Power Fuse on ASIC/2-8040

Effects: ASIC/2-8040

Date: July 7, 1998

Note No. TE014

Figure 1 - ASIC/2-8040 Board Layout

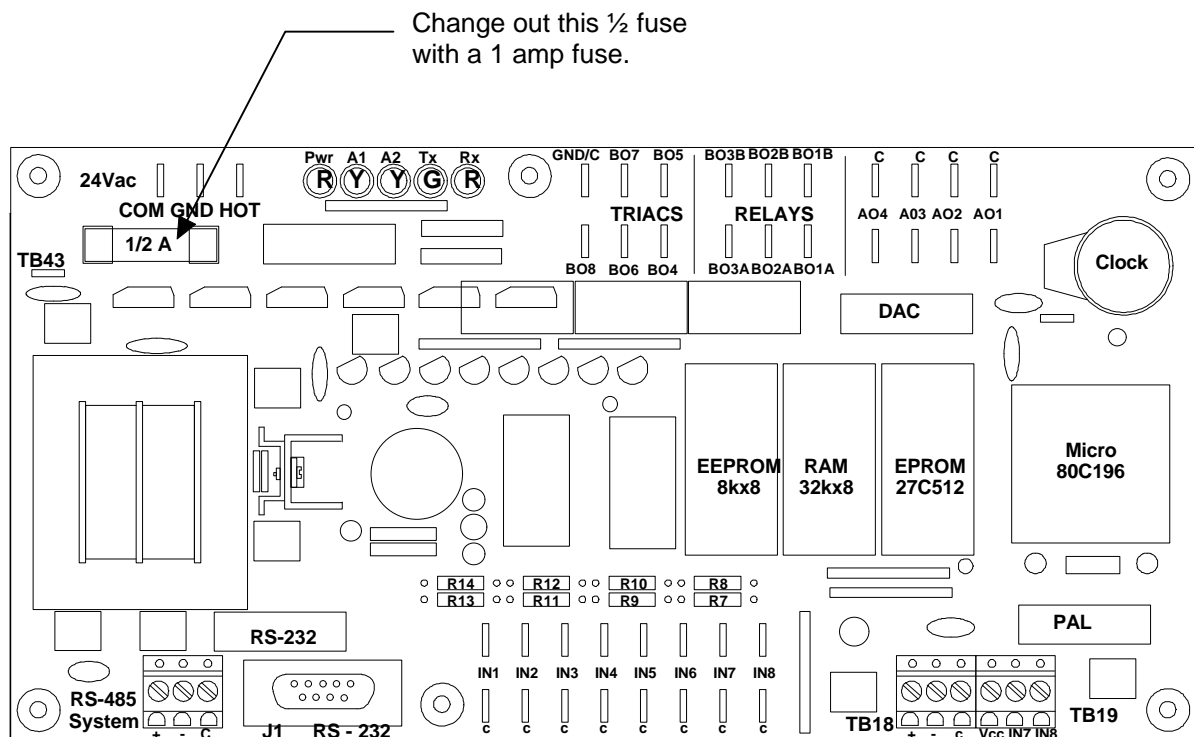
Our original specification for the ASIC/2-8040 required a ½ amp fast blow fuse for the controller power circuit. We have received reports from the field that the ASIC/2-8040 fuse is blowing unnecessarily. Through engineered testing, and within accordance of our UL mark, we have determined that the rating of the fused should be increased. Therefore, our latest specification requires a full 1 amp fuse.

All controllers to date have been shipped with the ½ amp fuse installed. If the controller is performing well there is no need to change out the fuse. However, if you are experiencing frequent fuse blows then we suggest changing out the fuse to 1 amp.

ASI Controls is happy to provide you with 1 amp fuse to replace the ½ amps. Please e-mail, fax, or telephone us and give us the number of fuses that you request for replacement. Standard terms and conditions apply to this situation. We will provide the fuses free of charge but will not pay any labor or other costs as a result of this issue.
